Venice Neighborhood Council

STAFF REPORT

City Case No:	APCW-2024-4822-CDP-CUB-SPPC-SPPE
CEQA Case No:	ENV-2024-4823-CE
Related City Case No(s):	n/a
Address of Project:	40-46 Windward Ave Lots 21 & 22, Block 2, Tract: Venice of America
Applicant:	Ann Everest (ann@generalrealestate.net)
Applicant's Representative:	Agent: Sarah Goldman / Pacific Crest Consultants (sarah@pccla.com) Architect: John Umbanhower / HUUM Architects (john@huum.com)
Standard of Review:	Coastal Act, with certified Land Use Plan (LUP) as guidance (for CDPs) Venice Community Plan Other applicable State laws: Assembly Bill 2097 and Density Bonus law, etc. Other applicable City laws: Al Fresco Dining, Zoning Administrator Adjustment (ZAA), Specific Plan Project Permit Compliance (SPPC), Specific Plan Exception (SPPE)
Coastal Zone:	Single / Multiple Permit Jurisdiction
City Hearing:	Not scheduled
Email for City Planner:	Sienna Kuo (sienna.Kuo@lacity.org)
LUPC Staff assigned:	David Turnbull (davidturnbull.lupc@gmail.com)

I. Detailed Project Description:

VII. Rendering of proposed project:

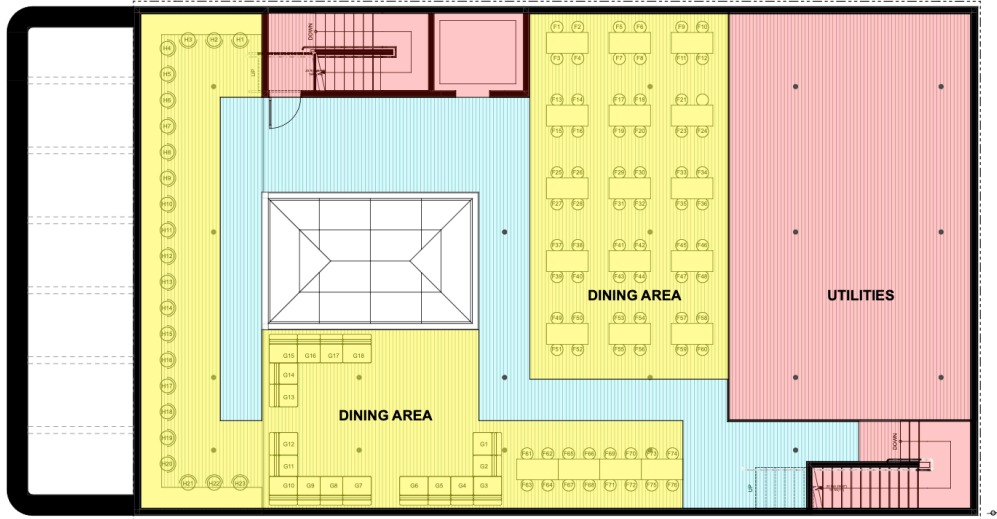
Note: The project is located within the Windward Avenue 'Historic Arcades' district, in a prominent location, governed by specific certified Land Use Plan requirements in relation to the restoration of the arcades (see below). The proposed project includes a reinterpretation of the historic arcade structure but does not replicate the circular columns or use the historic 'Peano' capitals.

In summary, the present project as proposed suggests an alternative, heterodox approach to the completion of the arcades, that is not dependent on historical quotation. This approach does not conform to the spirit and letter of the policy described in the certified Land Use Plan – Policy I.F.4. The project is also dependent on the approval of exceptions as follows:

VIII. **Floor Plans:** a. First Floor (top) + b. Second Floor (below)

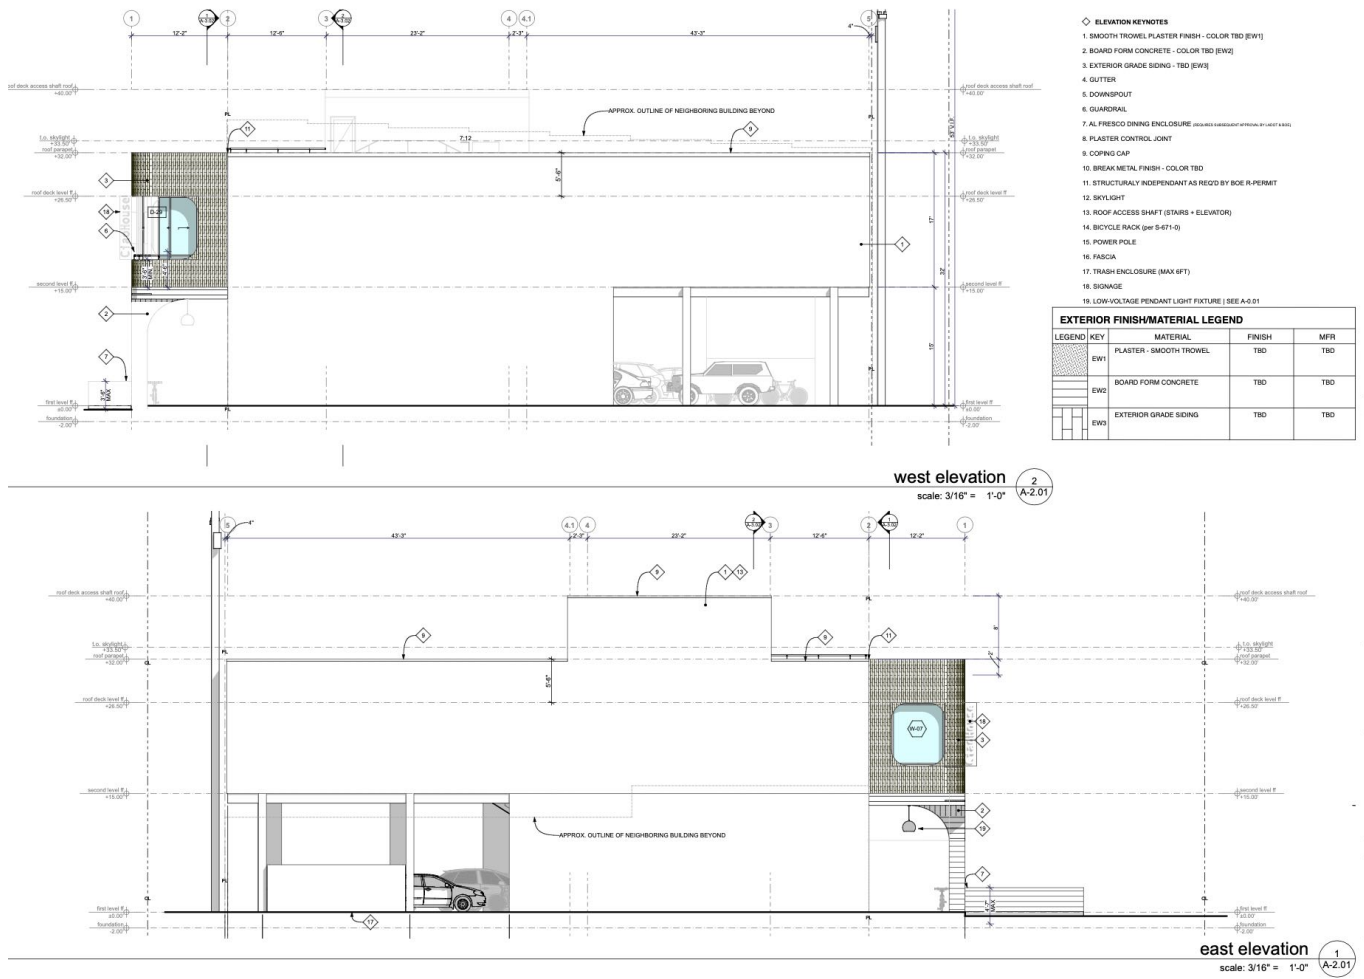
The Al Fresco space proposed here is very different from any application we have entertained thus far. That is because the current intention is for it to exist on three separate levels – on the street, above the arcade and then again on the rooftop. This is of special concern because of the way sound travels. The higher one is, the lower the barriers to sonic carry---and this danger is acute on a roof deck. The project already occupies an al fresco hotspot with over half a dozen other outdoor dining areas within just 500 feet. This concentration of potential noise, loitering and public urination demands strict scrutiny of the applicants plans and intentions.
